TENNESSEE VALLEY AUTHORITY
NUCLEAR SAFETY REVIEW STAFF

REPORT NO. R-85-02-SQN/WBN
SEQUOYAH AND WATTS BAR NUCLEAR PLANTS
SPECIAL REVIEW OF MANUFACTURER-IDENTIFIED
POTENTIAL MISAPPLICATION OF SWAGELOK TUBE
FITTINGS AT WESTINGHOUSE REACTOR SEAL TABLES

NSRS REPORT NO. R-85-02-SQN/WBN

SUBJECT: SEQUOYAH AND WATTS BAR NUCLEAR PLANTS -
SPECIAL REVIEW OF MANUFACTURER-IDENTIFIED
POTENTIAL MISAPPLICATION OF SWAGELOK TUBE
FITTINGS AT WESTINGHOUSE REACTOR SEAL TABLES

Figure 1 Bottom Mounted In-core Instrumentation System (BMIS)

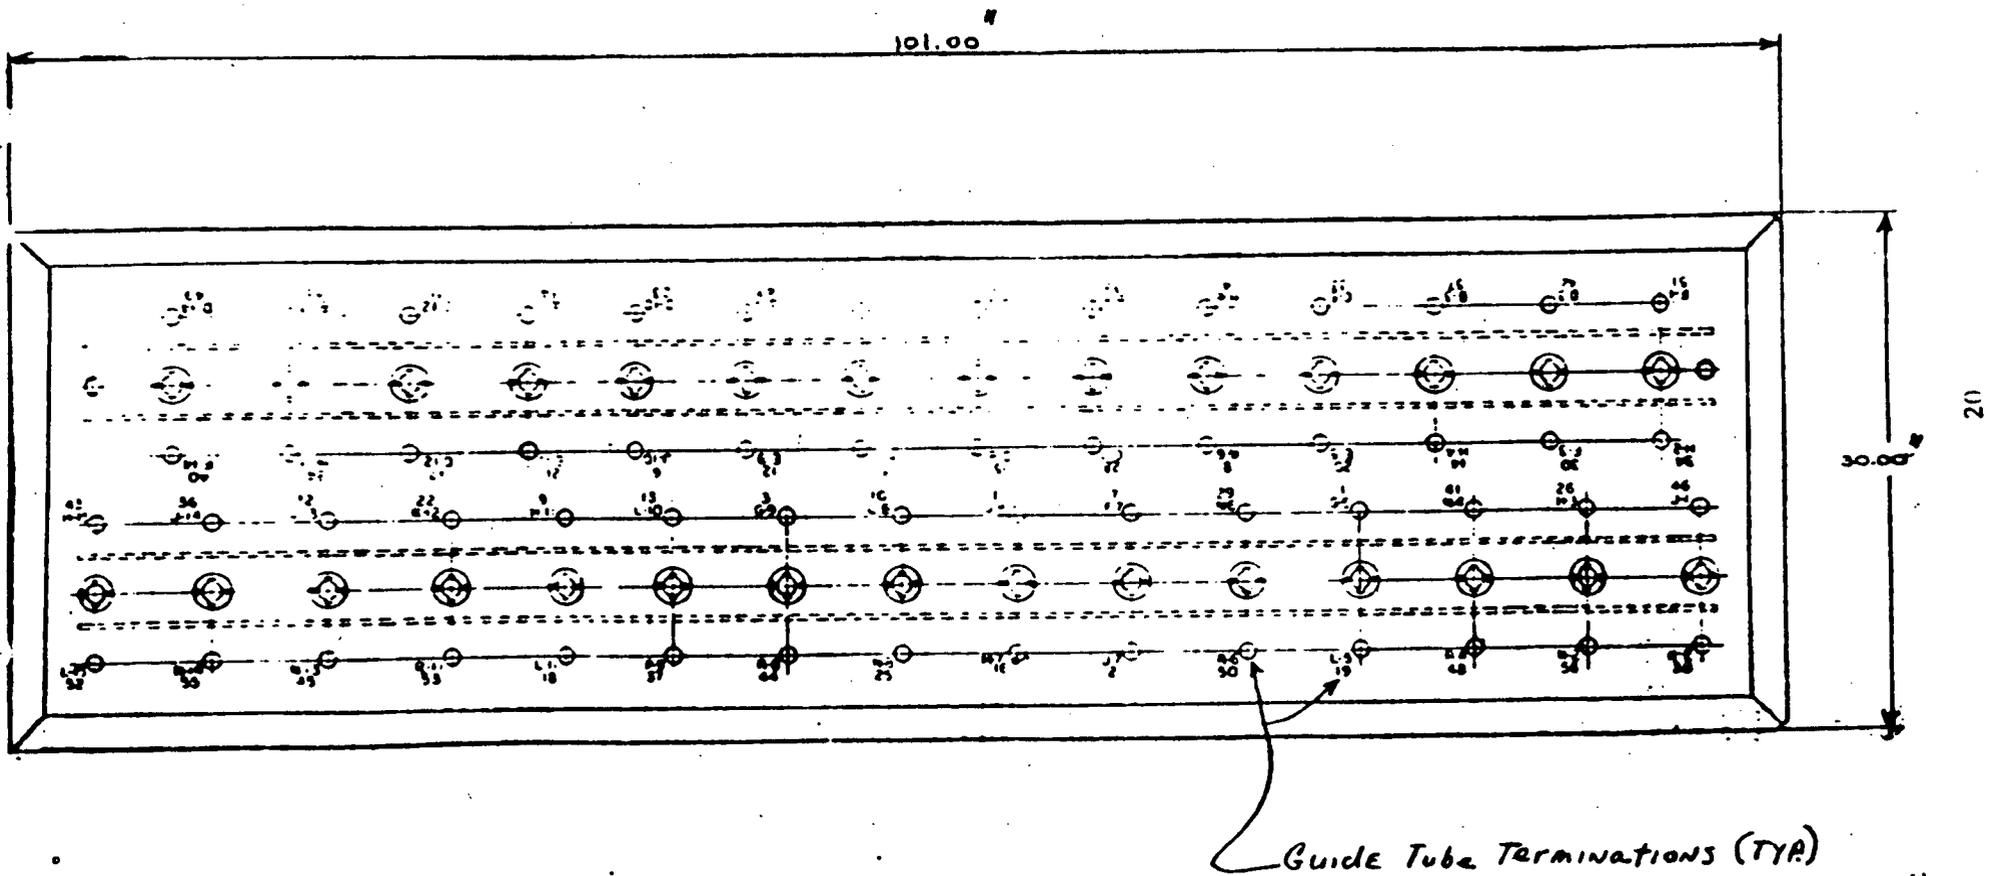
The tube fittings that are the subject of this review make up the high-pressure mechanical seals in the BMIIS (see figures 1 and 3). The BMIIS was designed to measure neutron densities at 58 different locations in the reactor core. The neutron densities are measured by 6 miniature fission chamber detectors that are driven into and withdrawn from the reactor core by electric drive units and cables through 58 small (0.201-inch inside diameter) stainless steel tubes called thimble tubes. Each thimble tube (~ 103-117 feet long) is housed in its respective guide tube which is 1 inch in diameter and is essentially an extension of the reactor pressure vessel. The guide tubes terminate at a common header type device referred to as the "seal table" (see figure 2). The thimble tubes are held in place against normal reactor operating pressure by high-pressure mechanical seals made up of tube fittings consisting of two ferrule assemblies (each assembly has two ferrules), a reducer union, and two nuts (see figure 3). Each seal establishes two reactor pressure boundaries (one on the guide tube and the other on the thimble tube). Improper assembly, excessive forces, or damage to these mechanical seals can cause leakage of reactor coolant and under severe conditions can cause partial or complete ejection of the thimble tube from its guide tube. Leakage from these seals cannot be isolated and it may be necessary to shutdown, cooldown, and depressurize the reactor to allow draining the coolant level in the reactor vessel below the elevation of the seal table to

SEAL TABLE HIGH-PRESSURE MECHANICAL SEAL
ASSEMBLY (TYPICAL 1 OF 58)

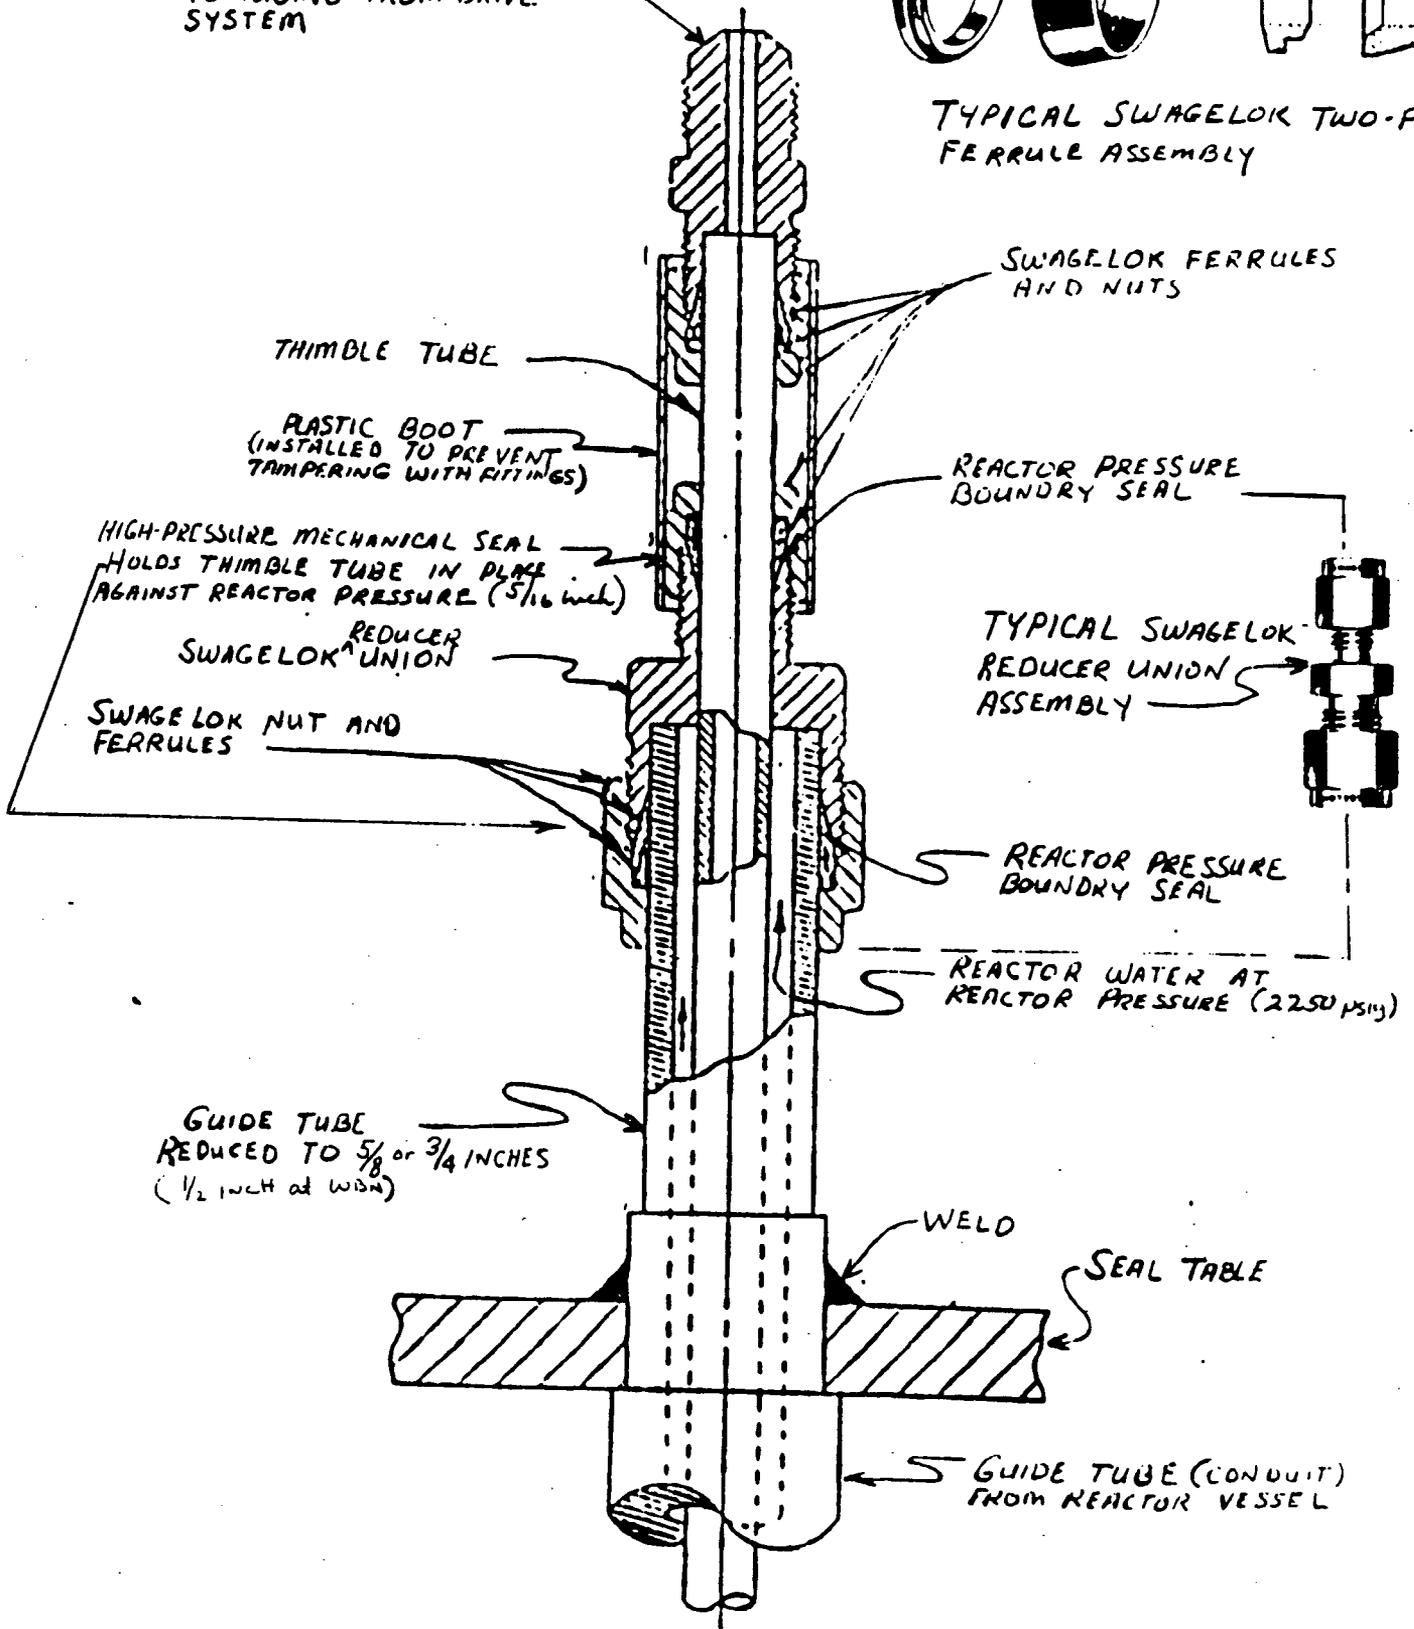
or to the nuclear fuel. To accomplish this operation the water level in the reactor is lowered below the elevation of the seal table. The overhead transfer assembly is disconnected from the thimble tubes at the union flare fittings (see figure 3) and the overhead assembly is rolled from over the top of the seal table. The 5/8- or 3/4-inch (1/2-inch for WBN) range nuts that form the lower reactor pressure boundary seals and hold the ferrule assembly in place on the guide tubes are loosened and approximately 15-20 feet of each thimble tube along with the 5/16-inch reactor pressure boundary seal is pulled out of its respective guide tube. A low-pressure seal supplied by W and consisting of a slotted plug (must be slotted to fit around the thimble tube), two half-metal washers, and a rubber castrate ring not supplied by W are then installed around each thimble tube. The slotted plug is threaded into the 5/8-, 3/4-, or 1/2-inch range nut and tightened to form the low-pressure seal (see figure 4). The reactor water level can then be raised to fill the reactor vessel and the refueling cavity and movement of irradiated and new nuclear fuel can begin. The low-pressure seals prevent the water in the refueling cavity (higher than the seal table) from leaking at the seal table. Following refueling operations the low-pressure seals are removed, the thimble tubes are reinserted, and the high-pressure mechanical seals are reassembled for normal operation. Final integrity of the high-pressure seals after reassembly cannot be demonstrated until the primary system is repressurized after the refueling outage.

A guide tube ferrule assembly inspection step had been added to MI-1.9, "Bottom-Mounted Instrument Thimble Tube Retraction and Reinsertion," that should be effective in preventing reassembly of the high-pressure seals with displaced ferrule assemblies on the guide tube. However, step 5.1.16 of SQN MI-1.9 implies that for a newly installed ferrule assembly on the guide tube the ferrule assembly can be SWAGED with the low-pressure seal cap. It is doubtful that the low-pressure seal cap can properly SWAGE the newly installed ferrule assembly as it is not designed for that purpose. Step 5.1.17 allows snugging the low-pressure seal with a wrench if leakage occurs while raising the water level in the reactor cavity, but no maximum torque value is specified to prevent displacing the ferrule assemblies on the guide tubes.

MI-1.9 should be revised to clarify that the low-pressure seal cap cannot be used to properly SWAGE newly installed guide tube ferrule assemblies. Reference should be made to SMI-0-94-3, "Seal Table High-Pressure Seal Repair," for high-pressure mechanical repair or proper replacement of new ferrule assemblies on the guide tubes. Some maximum value past handtight should be specified for the low-pressure seal and a caution should be added to prevent exceeding the maximum value which could cause displacement of the ferrule assemblies on the guide tubes.

LOW-PRESSURE SEAL USED DURING
REFUELING OPERATIONS WHEN THIMBLES
ARE RETRACTED

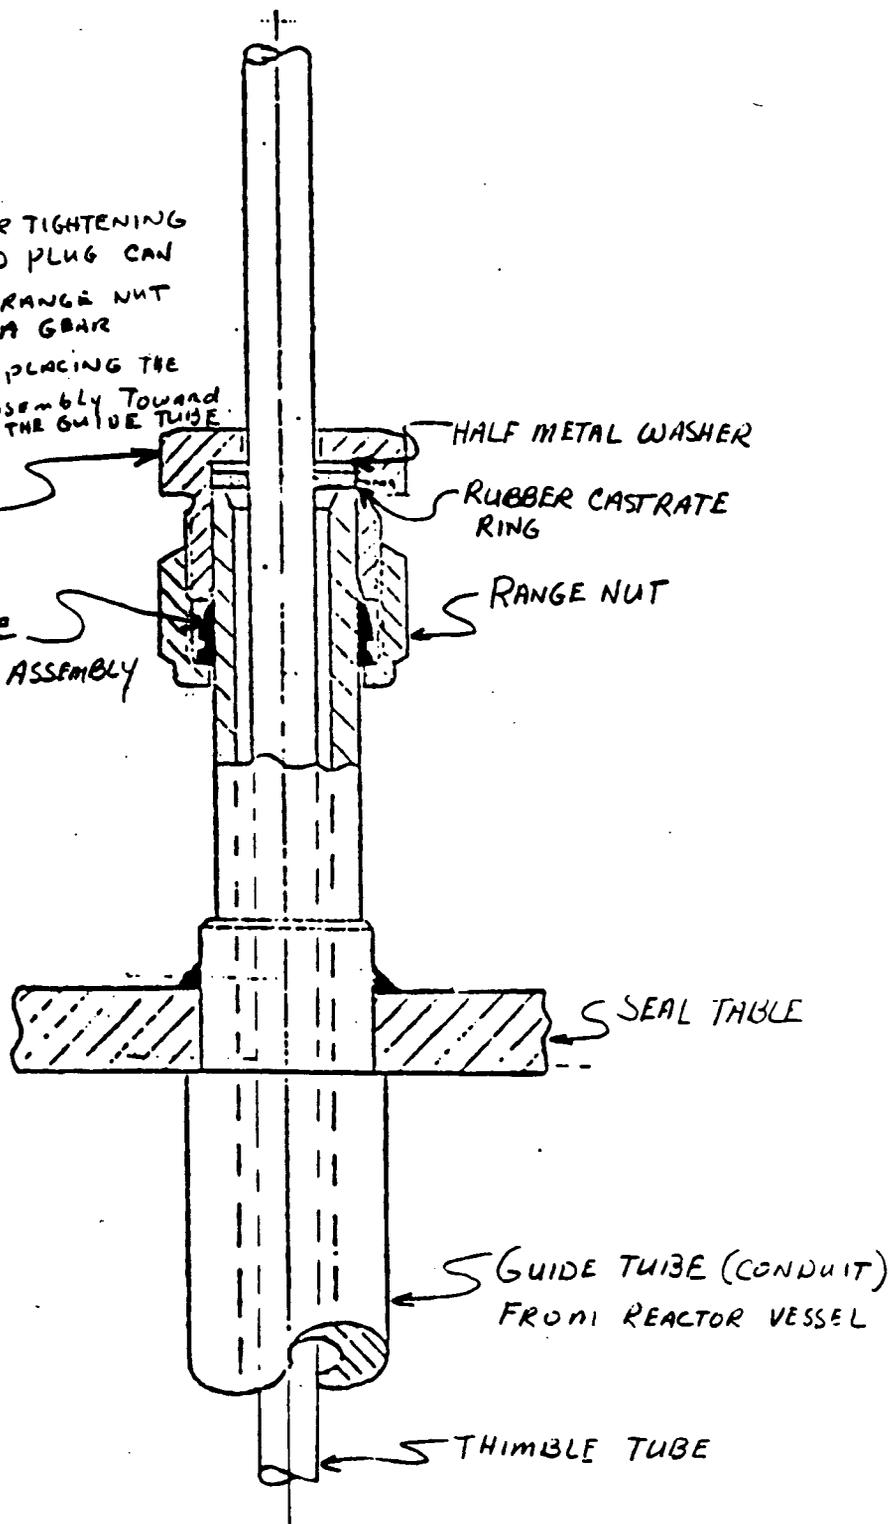
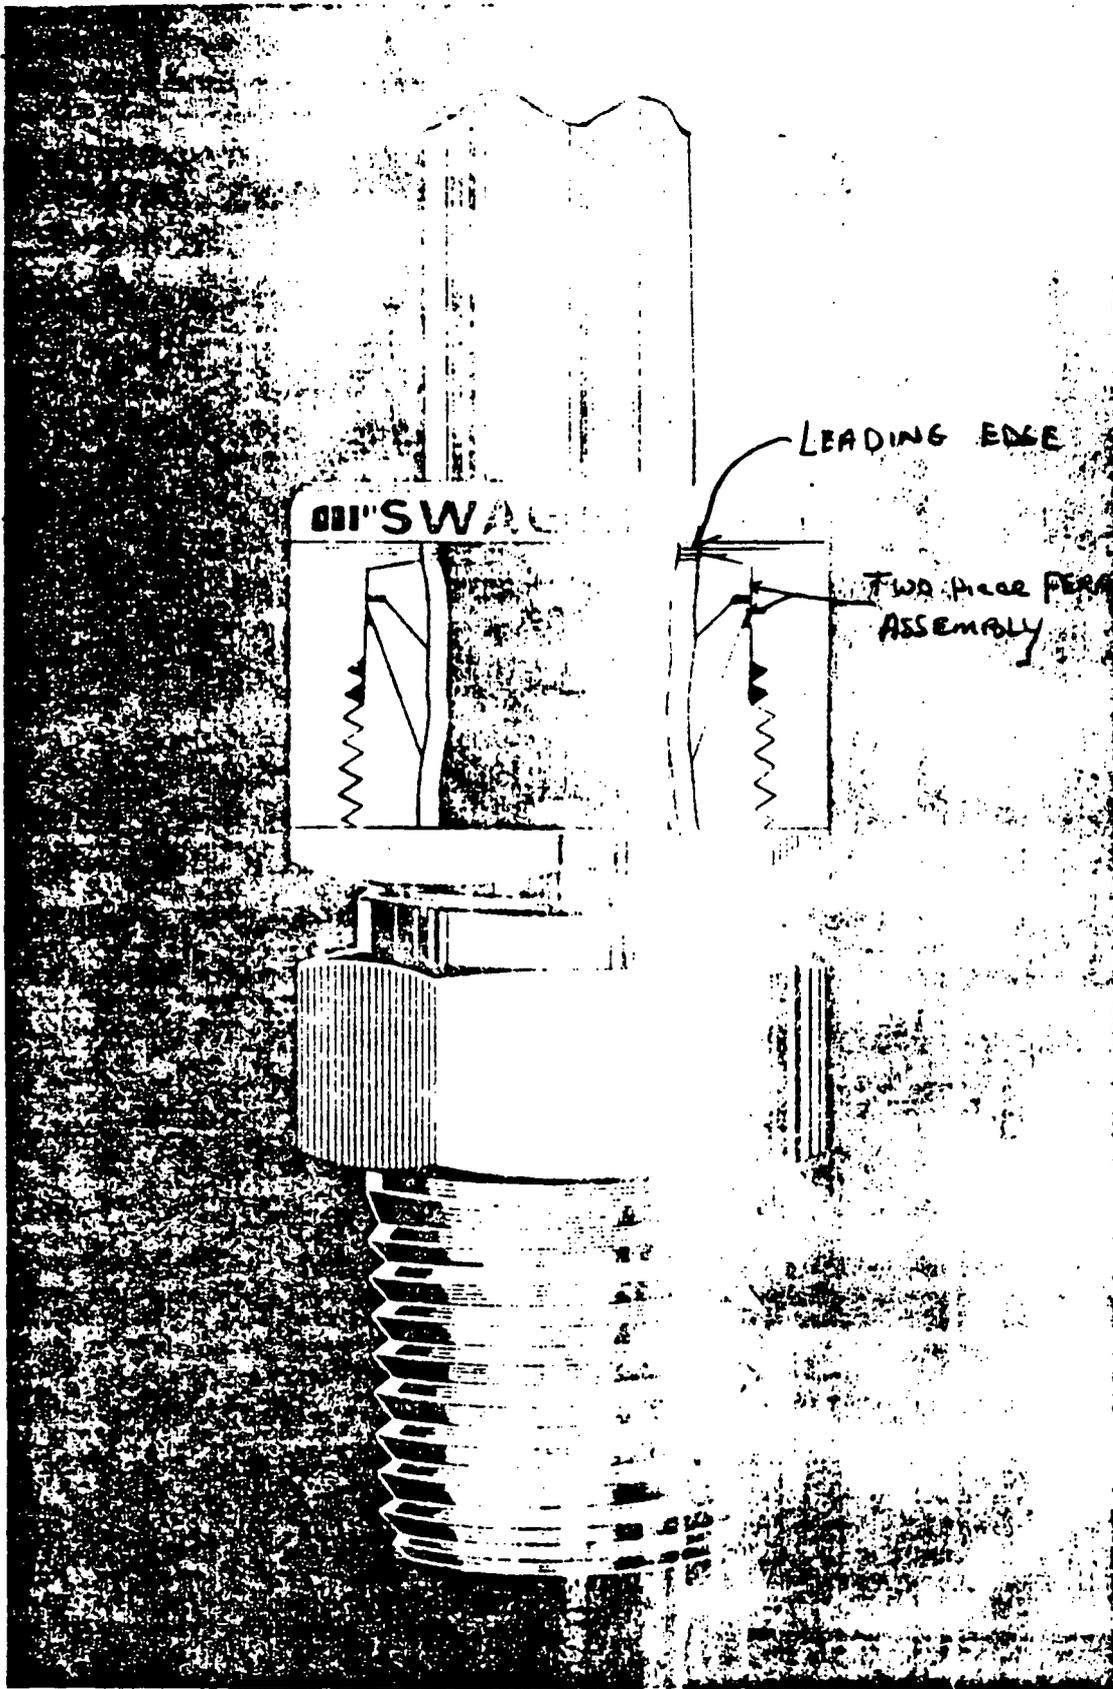
Use of the W modified and supplied low-pressure seals had forced ferrule assemblies on the guide tubes out of their sealing position. Over-tightening of the range nut and the slotted plug could cause the range nut to act as a gear puller thus displacing the two-piece ferrule assembly out of its original position and up toward the end of the guide tube increasing the probability of seal failure when the system is pressurized after the refueling operations. The low-pressure seals were not standard SWAGELOK components but were SWAGELOK components modified and supplied by W.

SQN, in accordance with W recommendations, inspected the ferrule assemblies on the unit 2 guide tubes during the recent refueling outage after the low-pressure seal plugs had been removed. They found some seal degradation (loose or displaced ferrules) on five guide tubes that could have been caused by use of the low-pressure seal cap. These ferrule assemblies were subsequently inspected by a CFC representative and the plant staff and were determined to be satisfactory for service. No problems were encountered with these seals during the startup of unit 2.

NOTE: OVERTIGHTENING
THE SLOTTED PLUG CAN
CAUSE THE RANGE NUT
TO ACT AS A GEAR
PULLER DISPLACING THE
FERRULE ASSEMBLY TOWARD
THE END OF THE GUIDE TUBE.
